Parking Structures 10 and 22 Lighting Upgrade, Bldgs.
252 and 254
Project No. FM130288S/166-55
Addendum No. 3

ADDENDUM NO. 3

**Clarification Memorandum, Set No. 1
Parking Structures 10 & 22 Lighting Upgrade**

SKETCH S001

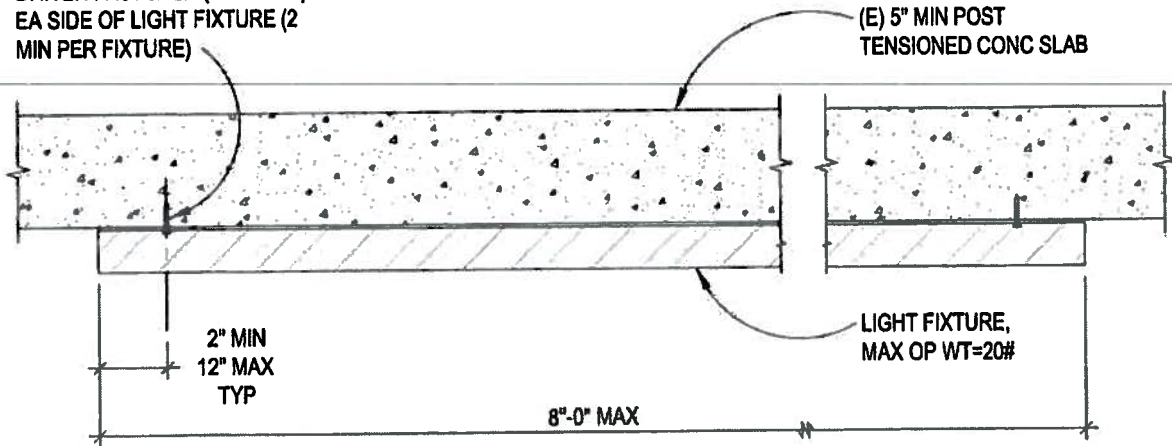
1. Parking structure 22 is a post tension concrete structure. When it was built we were not allowed to drill into the structure to mount the light fixtures. All of the anchorage was imbedded in the concrete. The problem is that all of the existing light fixtures are 8 feet and the new fixtures are 4 feet and the existing anchorage will not work with the new fixtures with the existing layout. How are the new light fixtures to be fastened to the structure? What will be required on parking structure #10?
New 4ft fixtures in parking structure #22 can mount directly to existing recessed junction boxes. New 8ft fixtures in parking structure #10 will require secondary fasteners as shown on SKETCHES S001 & S002.

Special care shall be taken when drilling the concrete shot pins as to not damage any existing tendons. Record drawings show tendons clear distance is 1-1/2" - contractor shall be aware of the potential for the tendons to be placed incorrectly during original construction. Caution should be taken during installation of new fasteners.
